INSTRUCTION TO SERVICE

ITS: 6333	
SECTION:	580 Wheelchair Ramp
WRITTEN BY:	Dwayne Peters
SUBJECT:	Lift U Torque Value Revision

Figure 3: 3/8" bolts, nuts, isolation blocks, and washers. Street side shown

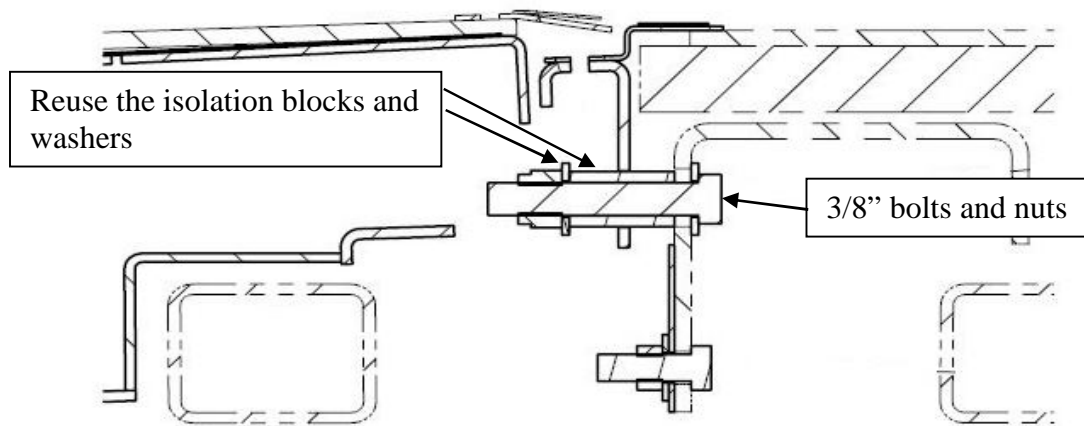
8. On the street side, one at a time, remove and discard the 3/8" bolts and nuts (three per bus) that mount the wheelchair to the bus structure. Reuse the blocks and washers. Use a new bolt NF # 10B06036 and a new nut NF # 10N06000 and torque to 58 FT-LB. **Do not use Loctite in this location.** Figure 3.

Figure 4: 3/8" bolts, nuts, washers, spacers and isolation blocks. Curb side shown

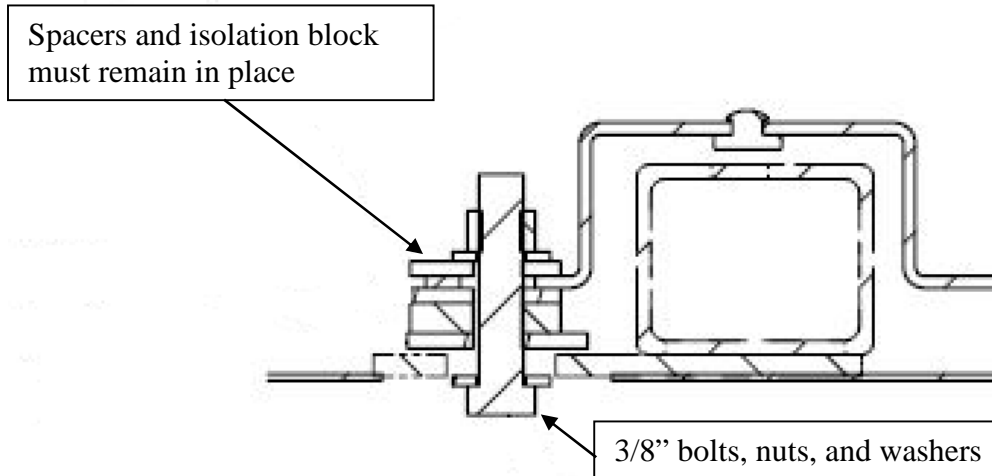
☞ **NOTE: The spacers and isolation block used between the bus structure and wheelchair ramp must remain in place. Figure 4.**

9. On the curb side, one at a time, remove and discard the 3/8" bolts and nuts that mount the wheelchair to the bus structure. Reuse the washers. Use a new bolt NF # 10B06028 and a new nut NF # 10N06000. Add a few drops of Loctite 243 to the threads and torque to 17 FT-LB. Figure 4.
